Sumter City-County Planning Commission

November 19, 2014

MSP-14-46/HCPD-14-31, 2625 Broad St. – Buffalo Wild Wings (City)

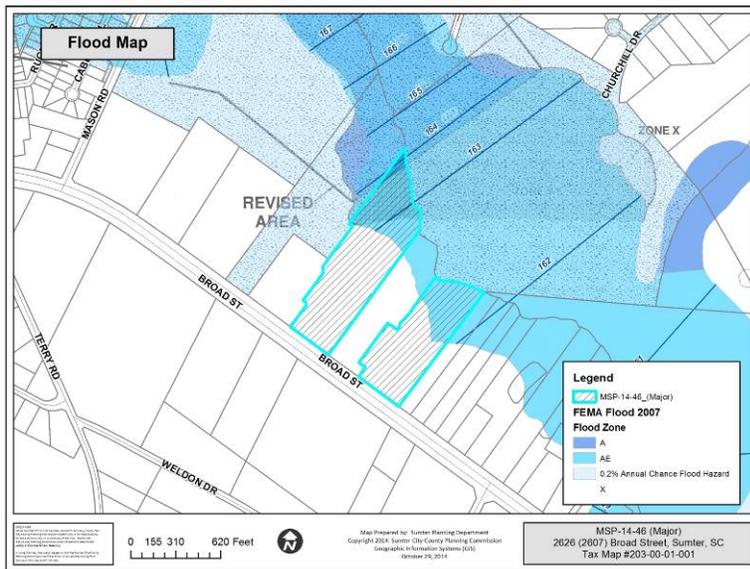
The tract proposed for development is bordered along the rear by Green Swamp. As shown in the Floodplain map to the left, according to FEMA FIRM Panel 45085C0284D, Effective Date February 16, 2007, about one-fourth of the property in the area along the branch is mapped Zone AE (shown in pale blue shading)

In addition, there are several acres of mapped and delineated wetlands within the proposed development site. The applicants plans show development will remain outside of designated wetland areas as well as the floodplain, as such the proposed development will not be subject to any additional development regulations associated with the Sumter Flood Damage Prevention Ordinance.

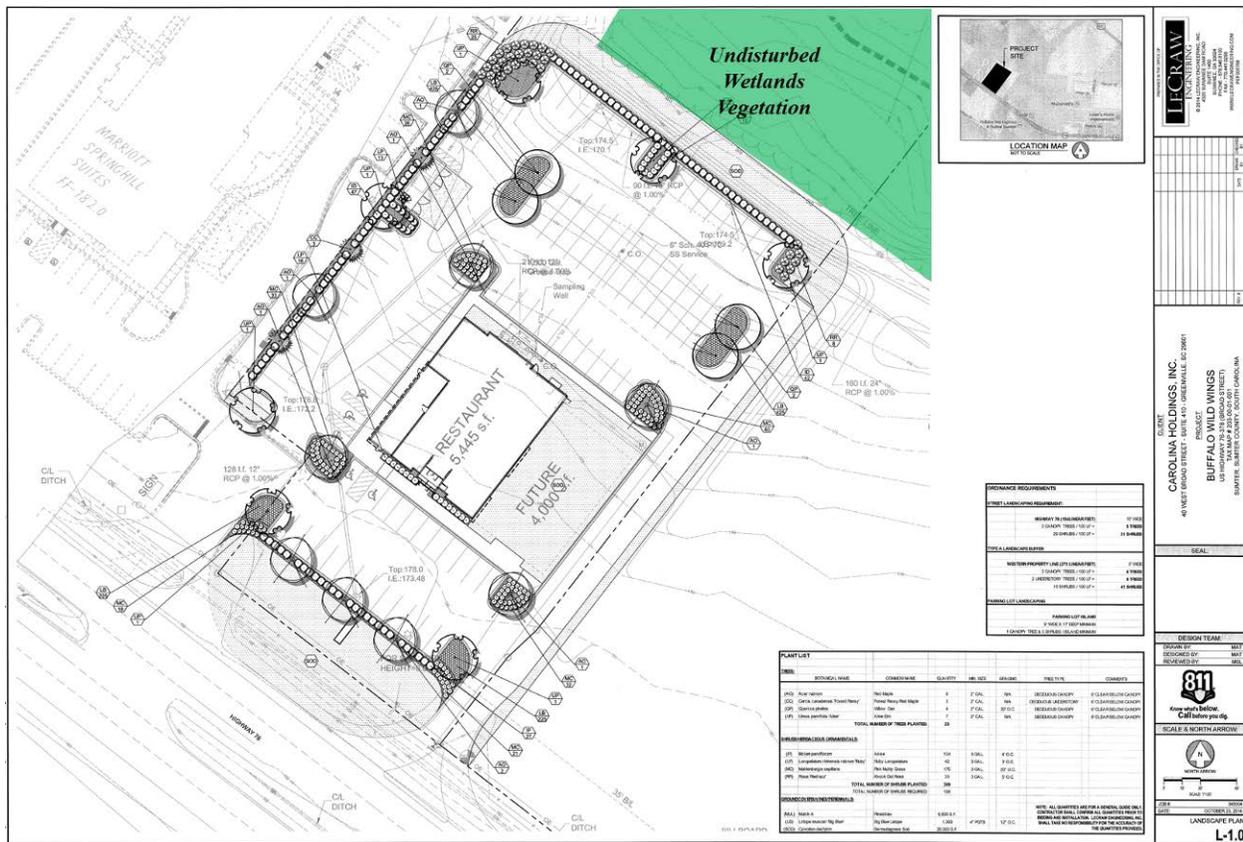
Submitted parking plans show the following:

- 105 regular 9 ft. x 19 ft. parking spaces;

- 3 regular handicap parking spaces
- 2 handicap van accessible parking space

The proposed parking lot plan exceeds the number of required parking spaces should the entire structure be developed for restaurant use.

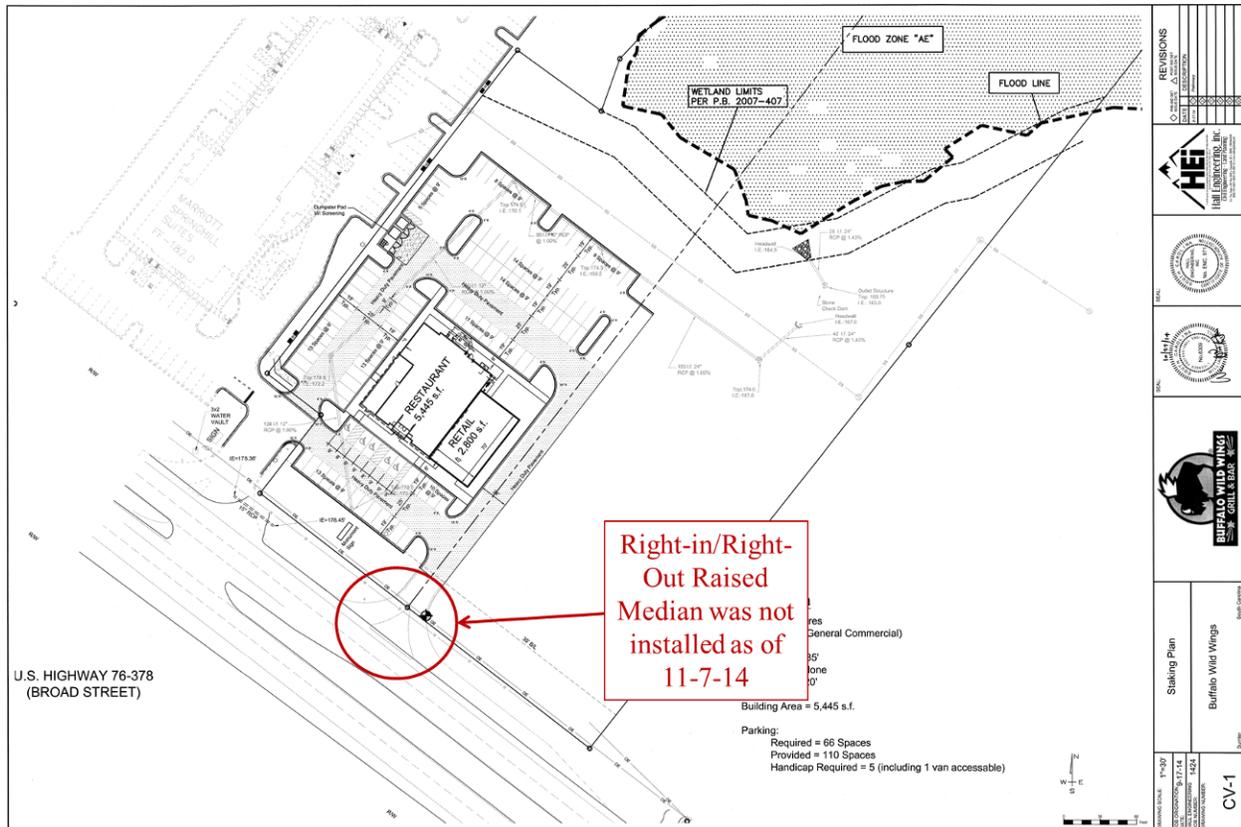
Ordinarily a Traffic Impact Study (TIS) would be required for a project of this size because it generates 100 or more peak hour trips, however; the Traffic Impact Study performed for the Springhill Suites site anticipated development of restaurants on this tract of land of a size larger than that currently being proposed. The parcel under review is part of a large land bay that has coordinated access. The encroachment drives were approved and installation was begun as part of the Springhill Suites Development. Currently the full access drive on the west side of the development site has been installed, and the groundwork and turn lanes have been installed for the right-in/right-out on the east side of the site, but full installation is not complete as shown in the graphic below.

Prior to issuance of a zoning certificate of occupancy for the site, the raised median and all appropriate lane markings and signage for the right-in/right-out drive must be installed, inspected and approved by SCDOT. The applicant is aware of this condition.

- Completion of the installation/SCDOT inspection and approval of the Right-in/Right-out access drive on the east side of the site to include installation of the raised median, required lane makings and signage prior to zoning certificate of occupancy.
- Submission of revised utility plans that meet the Utility Department's requirements.
- Provision of a fire hydrant within 100 ft. of the Fire Department Connection (FDC) for the building.
